**Re: 158A Mill Lane, London, NW6 1TF ; Planning Application (ref: 2011/4213/P).  
 Application for removal or variation of a condition following grant of planning permission.**

Please find enclosed an application for a section 73 procedure for the variation of a condition in relation to the minor material amendments to the granted planning application Ref. 2011/4213/P.

**Image 1: Laneway - View from Mill Lane**  
*(School and site to the right, Mansions building to the left)*

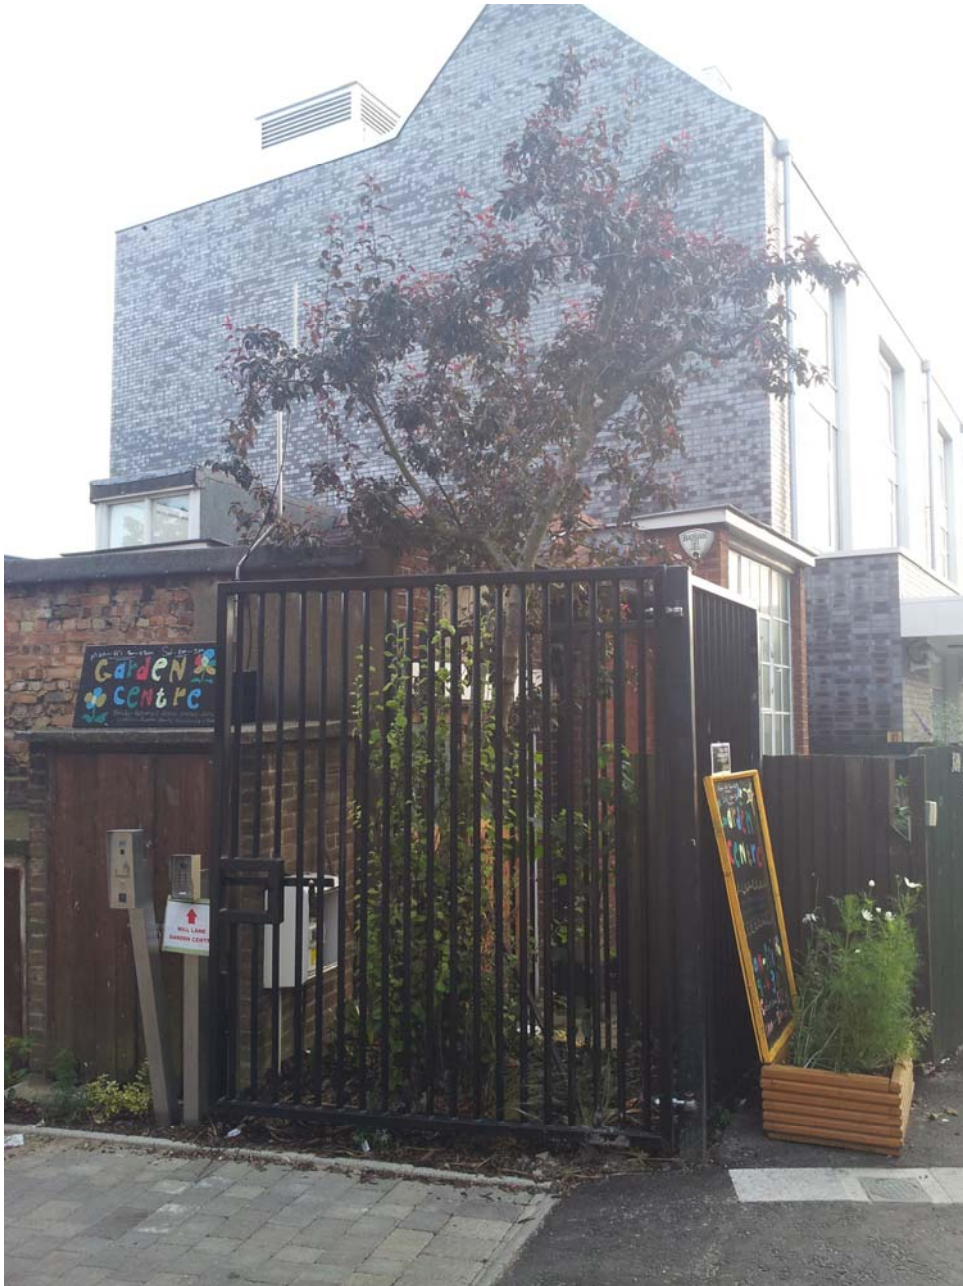
The trees that are proposed to be located down the side laneway should be removed from this application due to:

- a. The location where they were initially proposed has now been filled in/ completed by the works associated with the Emanuel School; including the installation of hard paving and lighting stanchions.

- b. If the trees were to be planted in the proposed locations, car access to the car park and the school garbage would be significantly hindered.
- c. The metre boxes at the front the lane way would need to be demolished and the services relocated. Also the services for the rear property run down that side of the driveway where the proposed trees are proposed, these would also need to be relocated.
